IN RE: PETITIONS FOR SPECIAL EXCEPTION AND ZONING VARIANCES - NS Joppa Road, 644' west of center line of Providence Road (414-416 East Joppa Road) - Ninth Election District

* BEFORE THE
* ZONING COMMISSIONER
* OF BALTIMORE COUNTY
* Case No. 89-246-XA

BALTIMORE COUNTY, MARYLAND
SUBJECT: COUNTY REVIEW GROUP COMMENT
FROM: OFFICE OF PLANNING AND ZONING DATE: 1/5/89

PROJECT NAME: The Traffic Group XXXXXX PLAN
PROJECT NUMBER: 1X-570

COUNTY REVIEW GROUP COMMENTS
PROJECT NAME: The Traffic Group
DATE: 1/5/89
PAGE 2

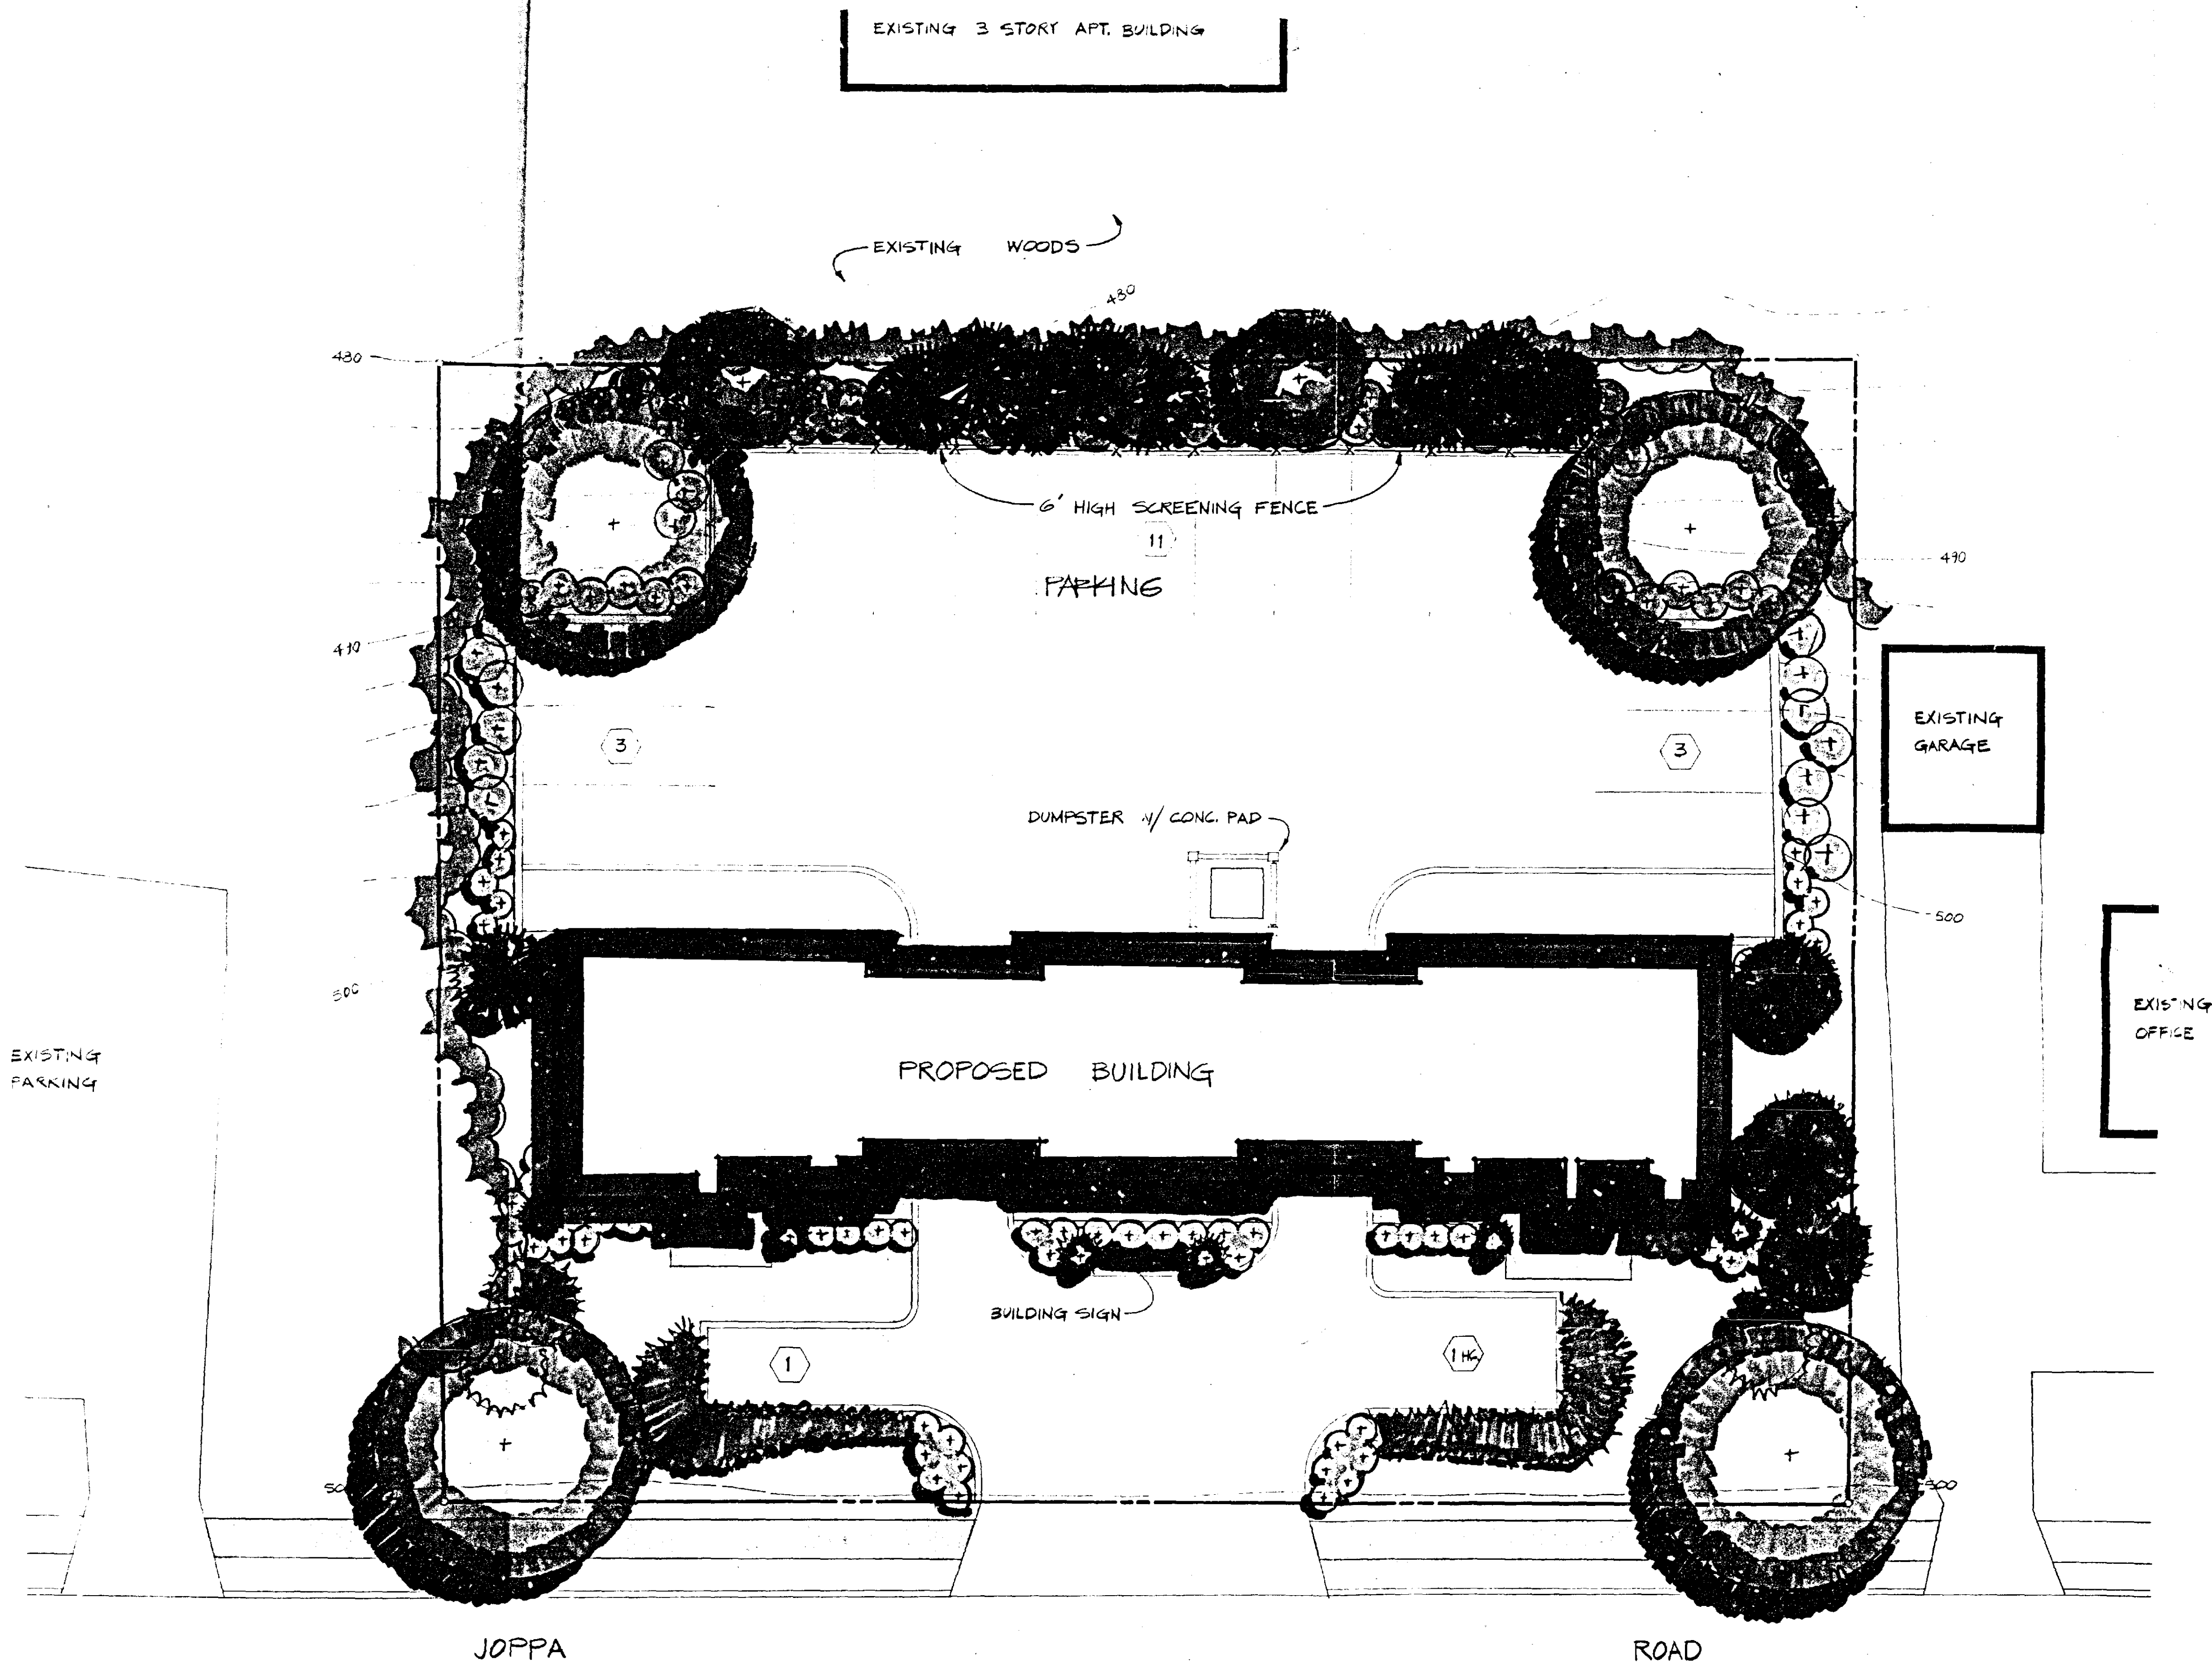
The petition and site plan for the zoning application and the C.R.G plan all should be revised to clarify all of the conflicts with the B.C.Z.R. and the petition should reflect the following sections:

2. Clarify that the dividing property line will be removed and that the properties will be combined into one metes and bounds description in the land records. If this cannot be accomplished, variances will be required to S.203.4.C.4 (side yard setback) 10 ft. required.

3. Include a scale sign detail with height, sq. footage, single or double face, and illumination indicated. Also include a detail or clarify the required minimum 5 ft. high screening between the R.O. and D.R.-16 zones (see Section 203.4.C.8.b. (B.C.Z.R.)); show existing stairwells (are they existing or proposed?); they were indicated on the Class "A" office approved site plan (RO-26); clarify the allowed and proposed F.A.R.; shade and subtotal in sq. ft. any qualifying A.O.S. areas if they will be provided and dimension all landscape buffer areas. 12/30-note that the basement will be used exclusively for parking and mechanical; clarify the two conflicting rear elevations, and clearly show the access for the basement parking; include complete floor plans including the basement and side elevations.

4. When the zoning petition and site plan is revised, all comments should be addressed and variance clearly indicated on the 10 required site plans. The 1" = 200' zoning map should be compared with the 1988 zoning map effective 12/4/88.
